April 26, 2000

40-8907

Re: Response to Agency Comments on the January 13, 2000 letter titled "Source Materials License SUA-1475, Technical Support for Proposed License Amendments" for United Nuclear Corporation Church Rock Site  
Project No. 32114, 40.300

**FIGURE 2**  
**ZONE 3 PROPOSED REVISED MONITORING WELL LOCATIONS**  
 PREPARED FOR:  
 UNC MINING AND MILLING  
 GALLUP, NEW MEXICO

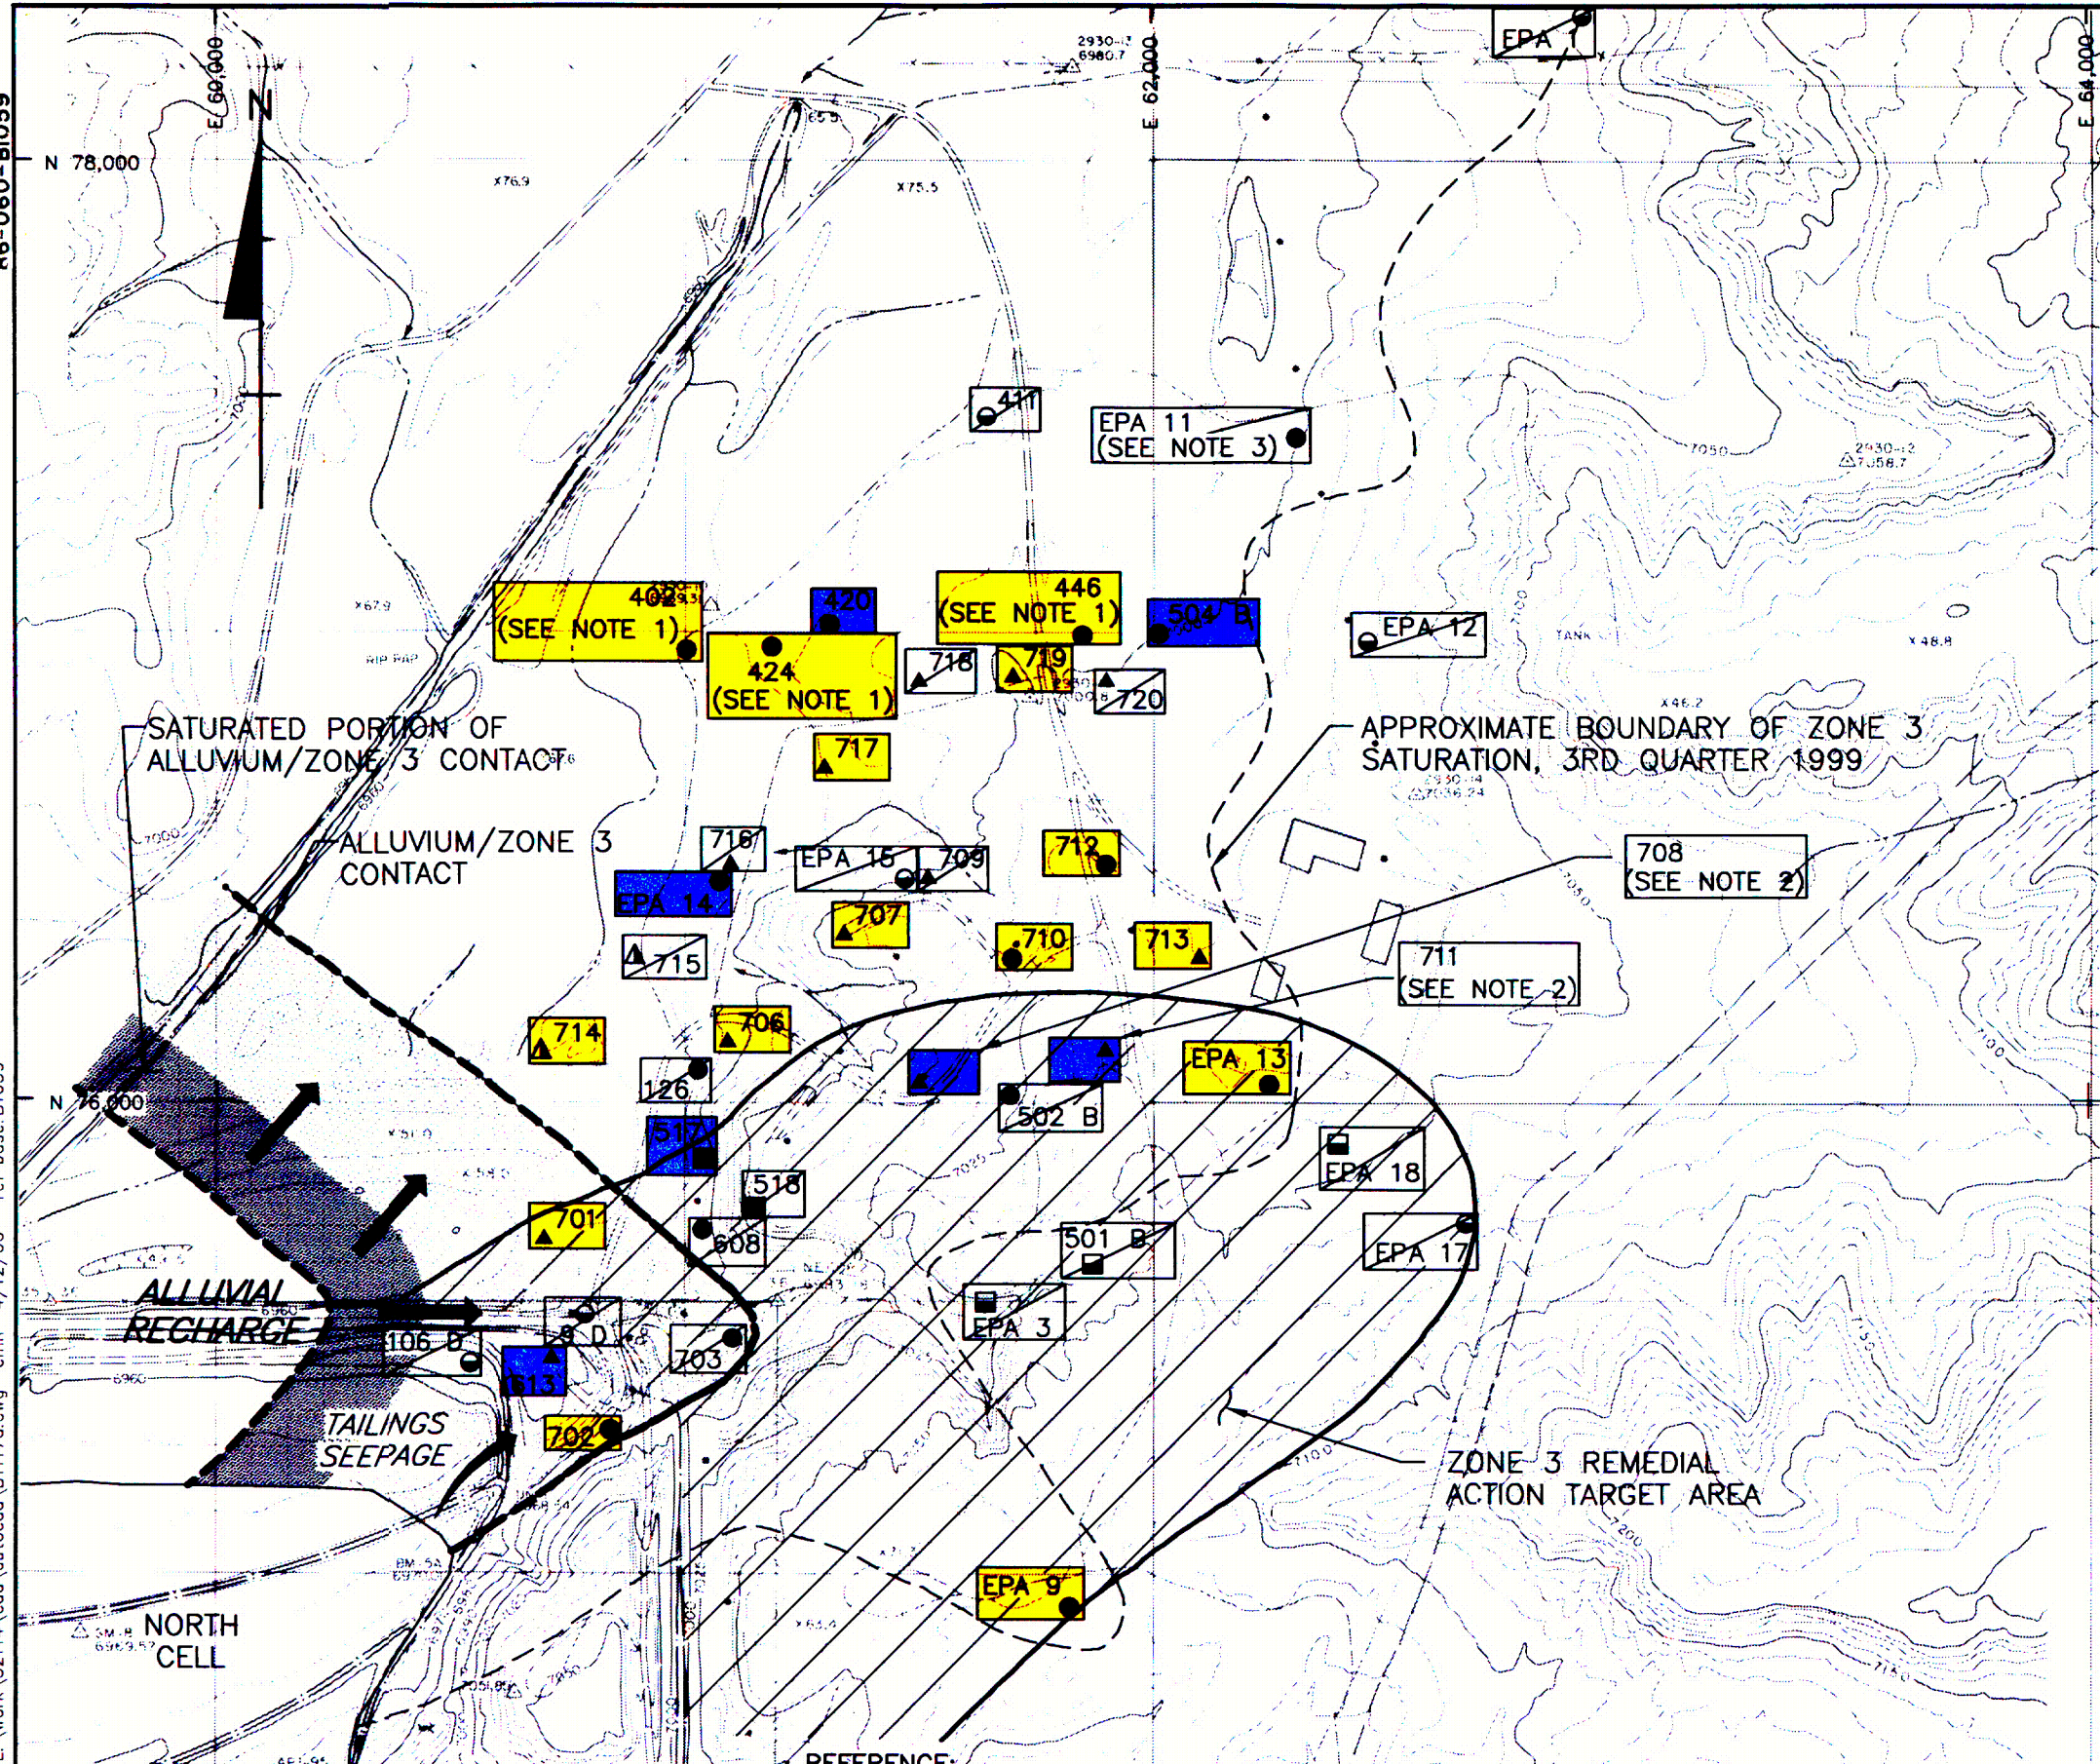
The three northernmost wells in Zone 3 have been deleted from the monitoring program. What is the rationale for deleting these wells. The information provided in Table 2 and the

information provided in Figure 2 does not agree. The information should be reconciled. An additional northern point of compliance well should be added to the monitoring program.

The three northernmost Zone 3 monitoring wells, EPA 1, EPA 11 and 411, were deleted from the program for the following reasons:

- Well EPA 1 was dry as of January 1998. This was documented in the 1998 Annual Review report and Well EPA 1 is designated as such in Table 2 and on Figure 2 of the January 13 letter.
- Well EPA 11 was no longer useable as of April 1990. At that time, the water level had dropped below the pump. United Nuclear attempted to lower the pump in the well but was unsuccessful because the pump was cemented in the well. This condition has been documented in the annual review reports since 1990. Because a water level probe cannot pass the pump, the level of saturation is not known in this well. However, based on water levels for wells in the vicinity, the water level at this well is expected to be 5 feet or less.

To reconcile the information in Table 2 and on Figure 2, the following revisions have been made:

- Table 2 - "Reason for Elimination" has been revised to state that Well EPA 11 has been unuseable since 1990 because the water level dropped below the pump, which was cemented in the well. Also, the shading indicating that the well is dry has been removed.
- Figure 2 - a note has been added stating that the well is not useable because the water level dropped below the pump, which was cemented in the well.

Copies of the revised Table 2 and Figure 2 from the January 13 letter are enclosed.

- Well 411 was no longer useable as of April 1998 because it has filled totally with oil. This condition was documented in the 1998 Annual Review and is stated in Table 2 of the January 13 letter. Figure 2 of the January 13 letter also shows the well with the symbol indicating that it is dry or "contains insufficient water for sample collection," which is the appropriate description for this well.

The need for and location of an additional Zone 3 monitoring well will be evaluated, but this determination is considered to be outside of EPA's request to revise monitoring procedures. If a well is added, the Source Materials License and the SOP will be amended to reflect such a change.
